IREDELL COUNTY HEALTH DEPARTMENT

Re: Application for improvement permit for **David Franklin,** property site **126 Spring Oaks Dr.,** Health Department file number **213004**

Based on the criteria set out in Title 15A, Subchapter 18A, of the North Carolina Administrative Code, Rule .1940 through .1948, the evaluation indicated that the site is UNSUITABLE for a ground absorption sewage system. Therefore, your request for an improvement permit is DENIED. A copy of the site evaluation is enclosed. The site is unsuitable based on the following:

SOIL/SITE EVALUATION
***for* ON-SITE WASTEWATER SYSTEM**
(Complete all fields in full)

SOIL/SITE EVALUATION

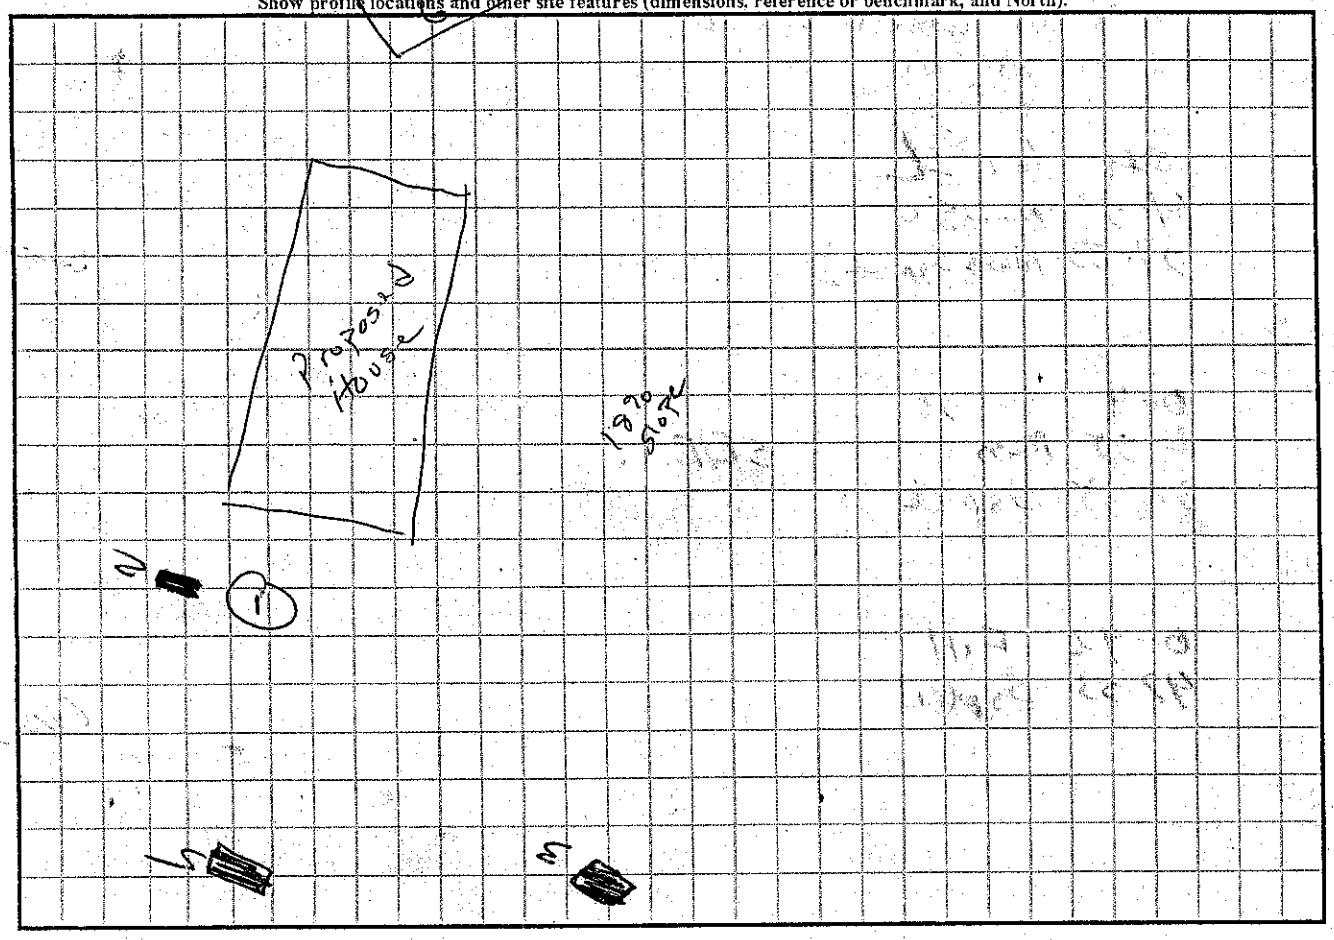
PROFILE #	.1940 LANDSCAPE POSITION/ SLOPE %	HORIZON DEPTH (IN.)	SOIL MORPHOLOGY (.1941) .1941 STRUCTURE/ TEXTURE	.1941 CONSISTENCE/ MINERALOGY	OTHER PROFILE FACTORS .1942 SOIL WETNESS/ COLOR	.1943 SOIL DEPTH	.1956 SAPRO CLASS	.1944 RESTR HORIZ	PROFILE CLASS & LTAR
1 APB	2% NS	0-7	SL Gr	fr mor SE					Need pits.
		7-18	C Y/B mottles	OBE					
		18-30	BC WABK	Fr mod SE					
		30-48	SAR	NP					
PIT 2	NS	0-4	Gr SL		Chroma 3 in C horizon	Prismatic Peds Horizon 11"-29"			LPNS
		4-31	Mass SC						
		31-53	mass SaPCL						
PIT 3	NS	0-4	Gr SL		(Ped 7")				LPNS
		4-35	Mass C	SE/E					
		35-55	SaP CL						
PIT 4	NS	0-42	Fill						LPNS
		42-53	SaP(Cl)

PROFILE #	.1940 LANDSCAPE POSITION/ SLOPE %	HORIZON DEPTH (IN.)	SOIL MORPHOLOGY (.1941) .1941 STRUCTURE/ TEXTURE	SOIL MORPHOLOGY (.1941) .1941 CONSISTENCE/ MINERALOGY	OTHER PROFILE FACTORS .1942 SOIL WETNESS/ COLOR	.1943 SOIL DEPTH	.1956 SAPRO CLASS	.1944 RESTR HORIZ	PROFILE CLASS & LTAR
		0-4	Gr SC						
		4-16	SBlC cL						
PIT 5		16-36	Mass C	SE/F					
		36-55	Mass RC C	Ped 7 1"
